Texas Department of Transportation

MINOR DESIGN UPDATES UNDER CONSIDERATION FOR FINAL DESIGN

CUSTER ROAD & FUTURE US 380 INTERCHANGE

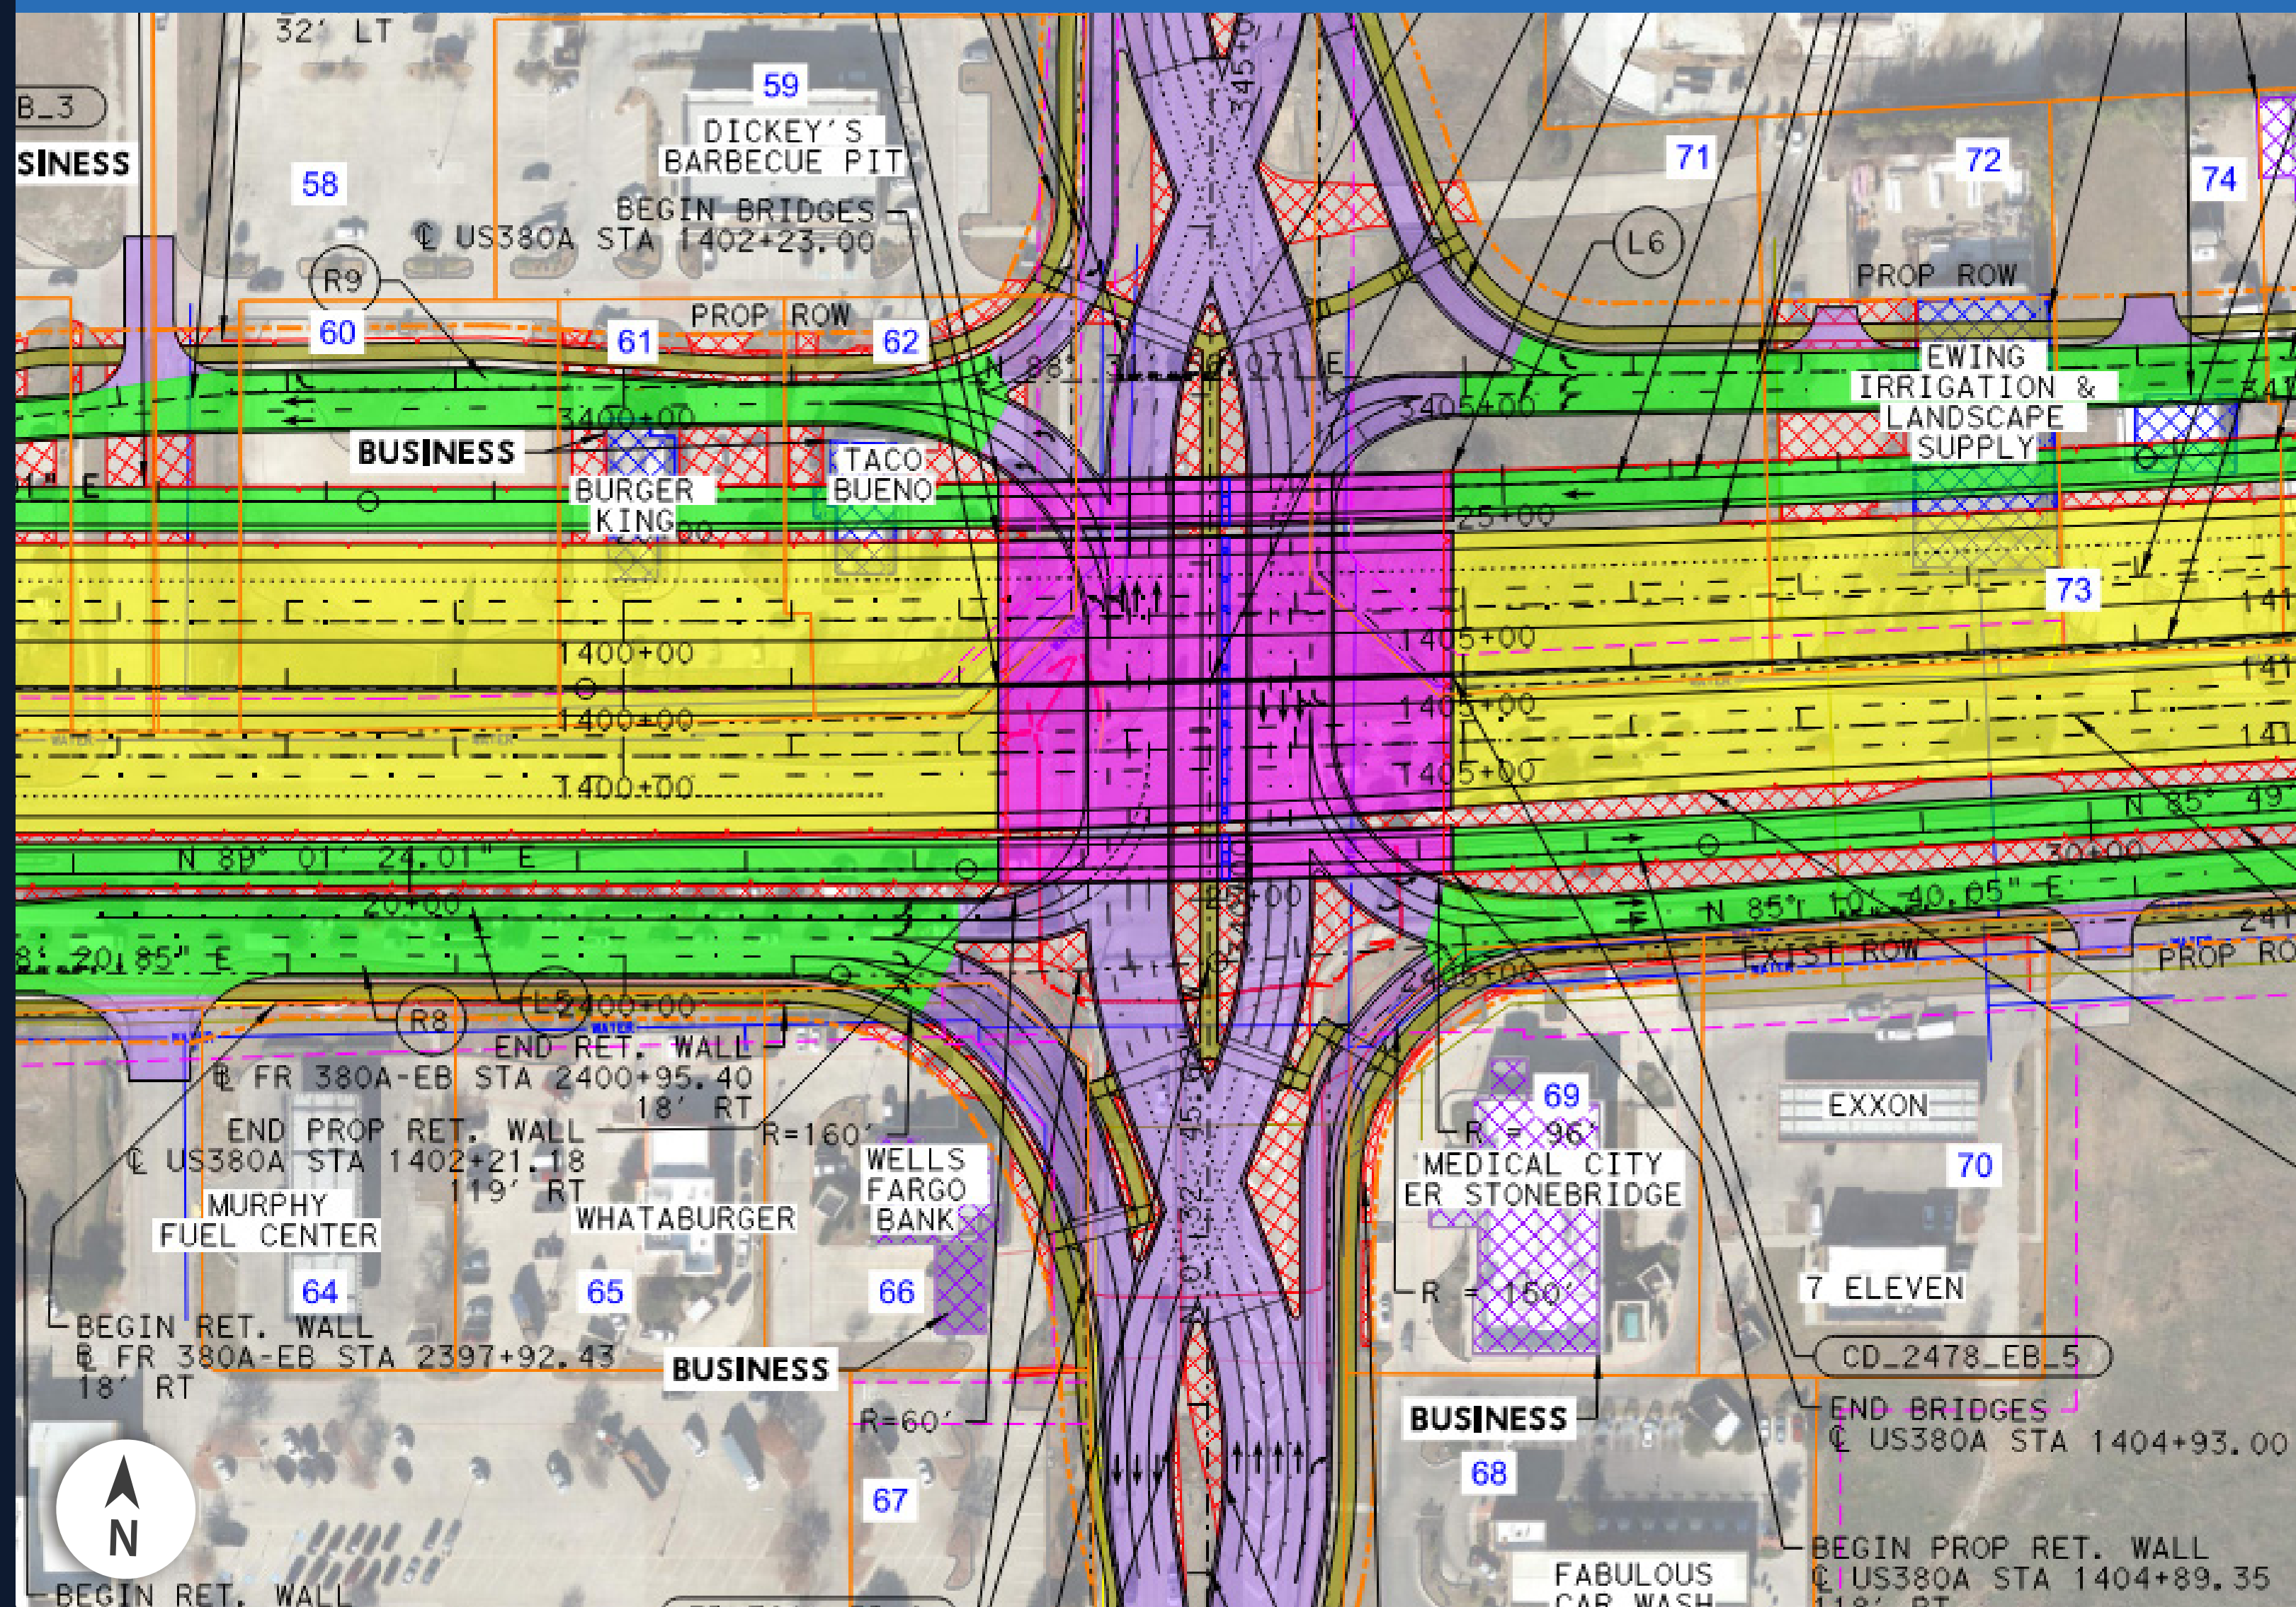
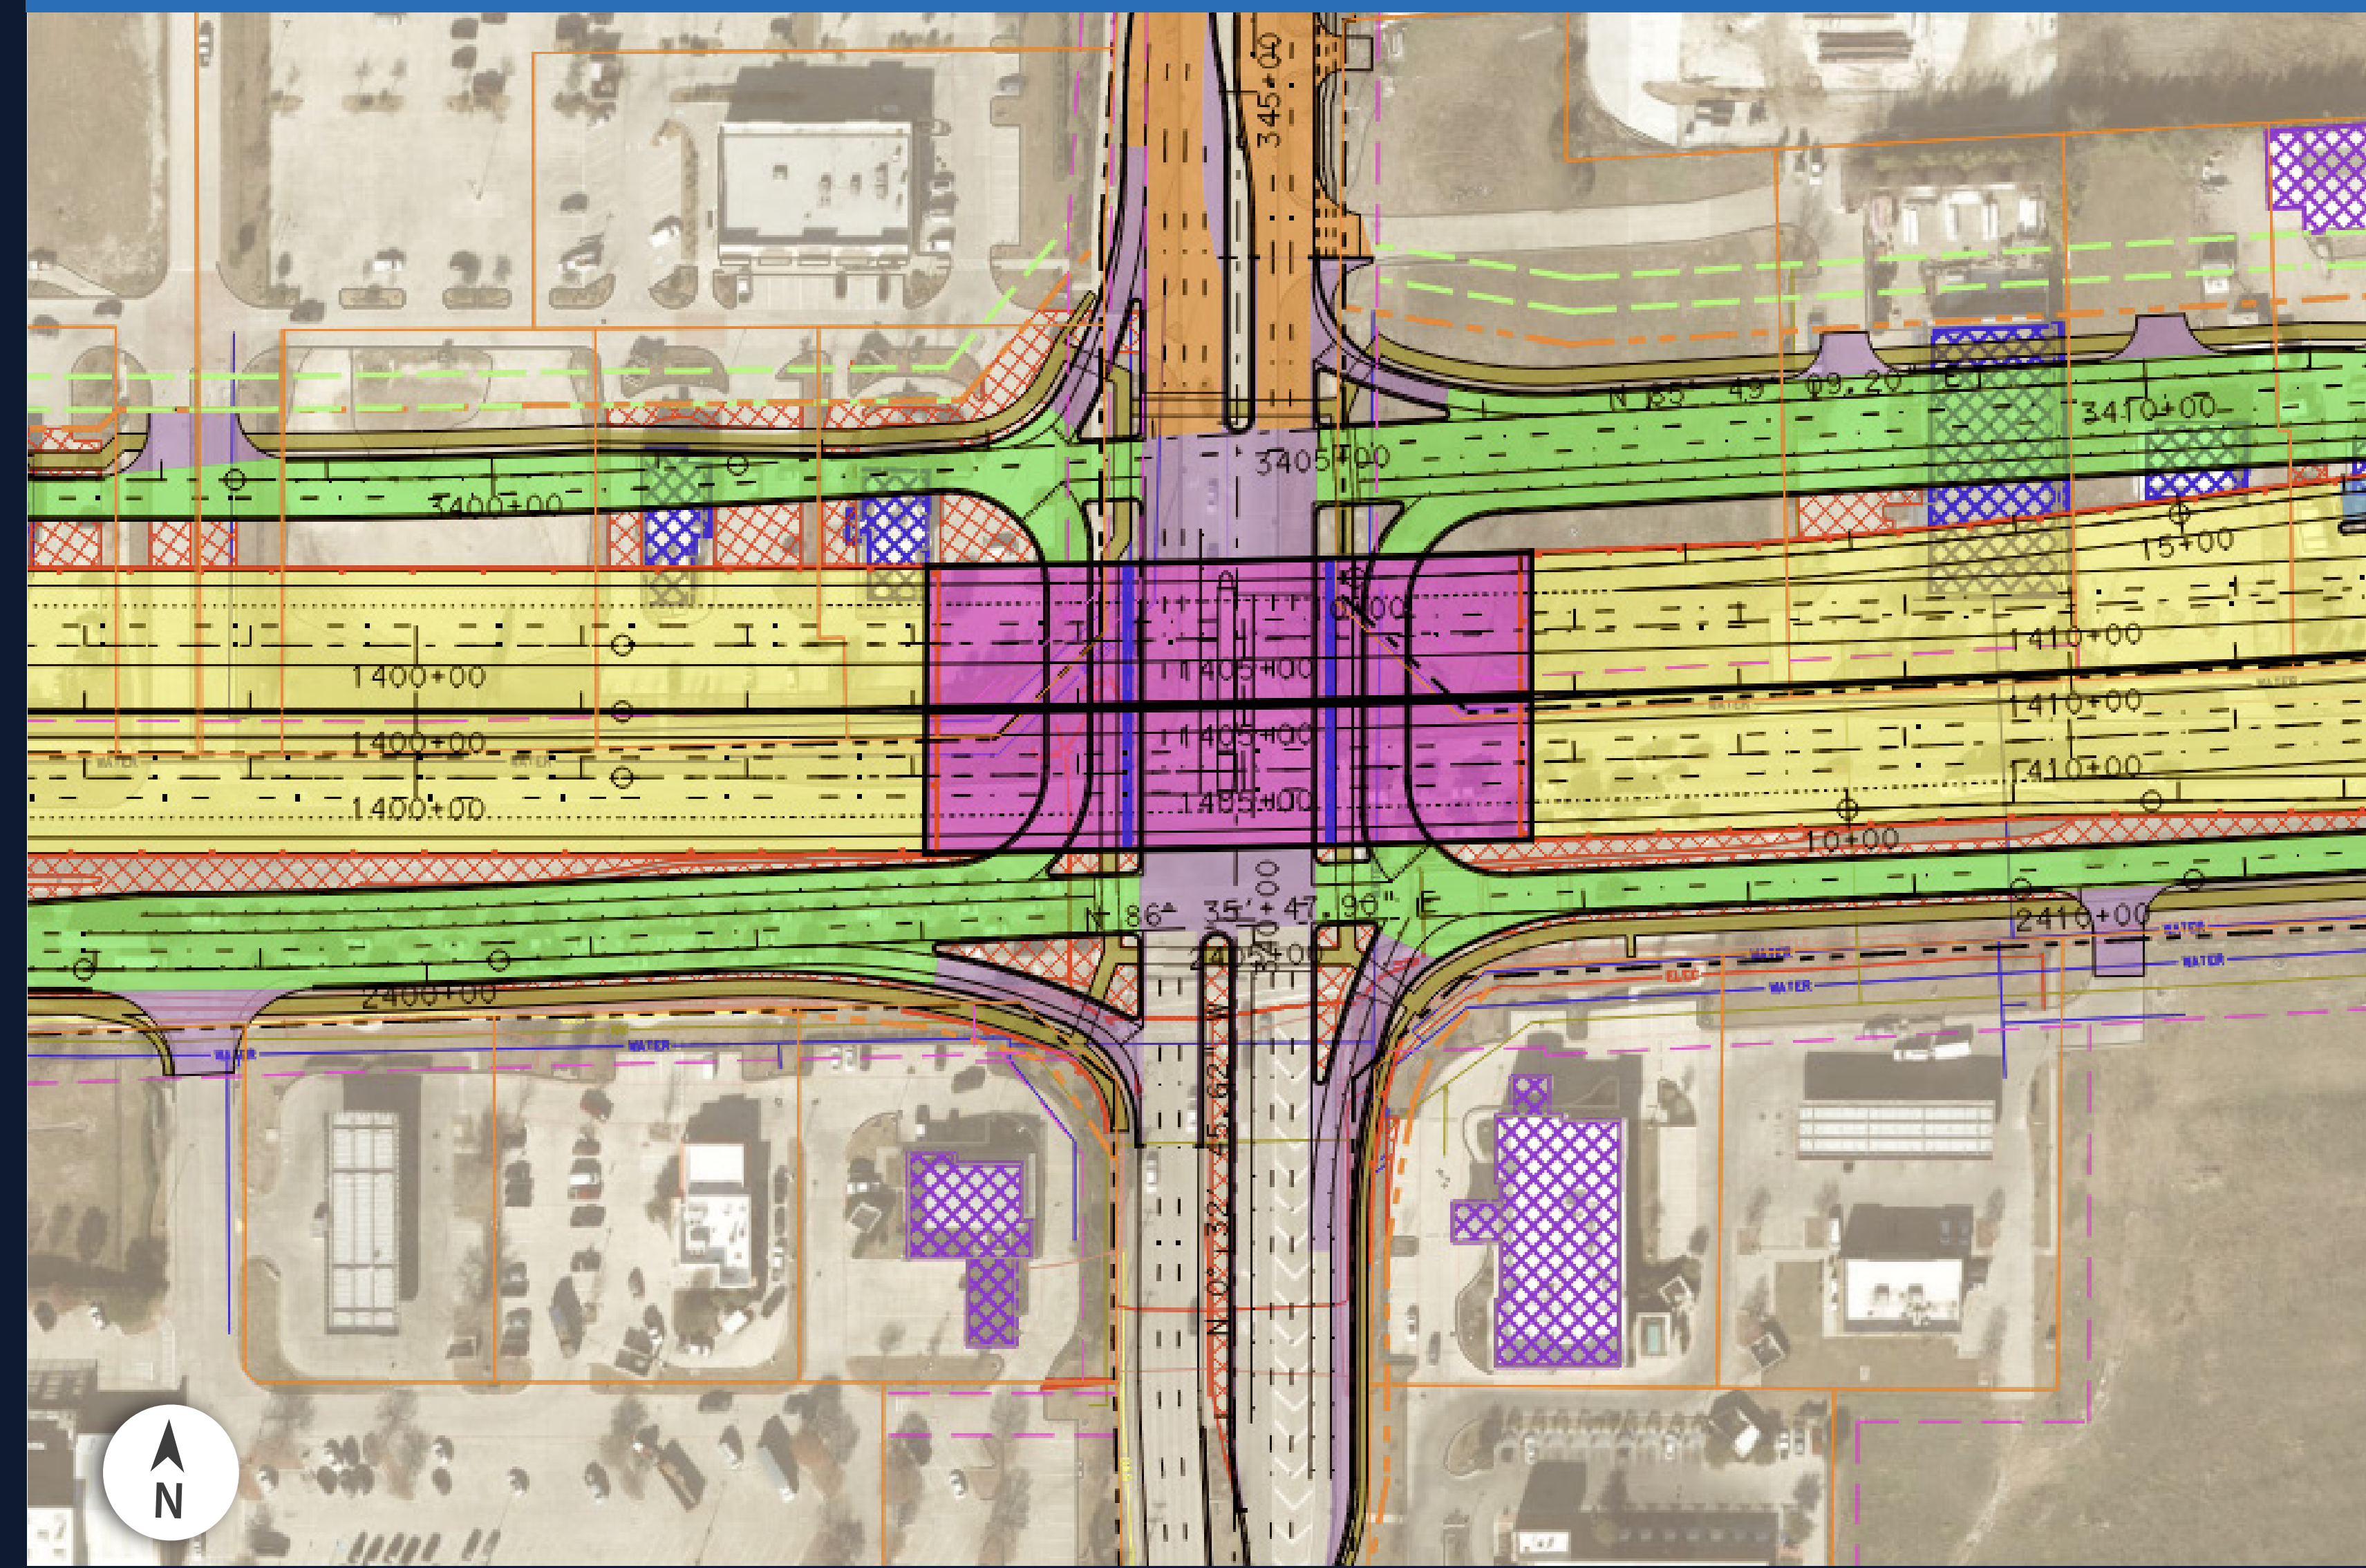
The proposed design would change the previously proposed diverging diamond interchange (DDI) to a traditional interchange design to minimize ROW impacts and improve driveway access to adjacent businesses.
